ADDENDUM NUMBER: Three (3)

TITLE: 1411921050 (IFB) BGS Standby Emergency Diesel Generator Integration

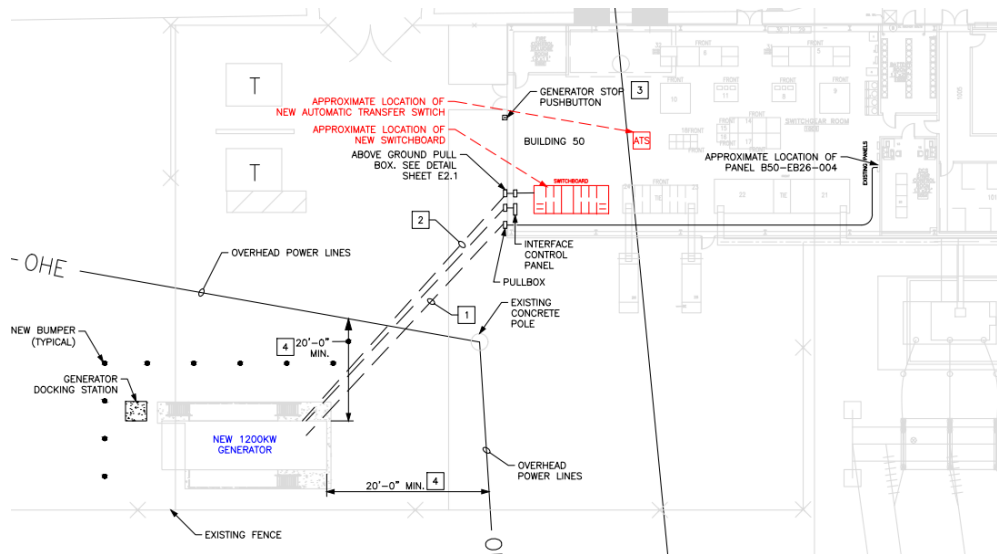
30. **Question:** Will conduit be required for the new comms cabinet?

Answer: No conduit will be required for the new Mark VI cabinet in Building 50.
